**PCN# 20130613001**  
**Add Matte Sn as Alternative Lead Finish for Selected SOIC Device(s)**  
**Change Notification / Sample Request**

**Date:** 6/27/2013  
**To:** MOUSER PCN

<b>PCN Number:</b>	20130613001		<b>PCN Date:</b>	06/27/2013							
<b>Title:</b>	Add Matte Sn as Alternative Lead Finish for Selected SOIC Device(s)										
<b>Customer Contact:</b>	PCN Manager	Phone:	+1(214)480-6037		Dept:						
<b>Proposed 1<sup>st</sup> Ship Date:</b>		09/27/2013	<b>Estimated Sample Availability:</b>		Date provided at sample request						
<b>Change Type:</b>											
<input type="checkbox"/>	Assembly Site	<input type="checkbox"/>	Assembly Process	<input checked="" type="checkbox"/>	Assembly Materials						
<input type="checkbox"/>	Design	<input type="checkbox"/>	Electrical Specification	<input type="checkbox"/>	Mechanical Specification						
<input type="checkbox"/>	Test Site	<input type="checkbox"/>	Packing/Shipping/Labeling	<input type="checkbox"/>	Test Process						
<input type="checkbox"/>	Wafer Bump Site	<input type="checkbox"/>	Wafer Bump Material	<input type="checkbox"/>	Wafer Bump Process						
<input type="checkbox"/>	Wafer Fab Site	<input type="checkbox"/>	Wafer Fab Mate

**Sample Product Shipping Label (not actual product label)**

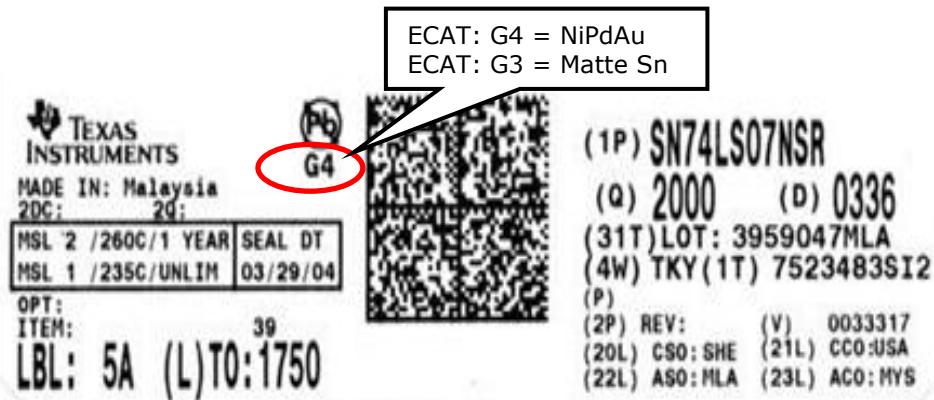
**Changes to product identification resulting from this PCN:**

ASEH	Assembly Site Origin (22L)	ASO:ASH	ECAT:G4
ASEH	Assembly Site Origin (22L)	ASO:ASH	ECAT:G3
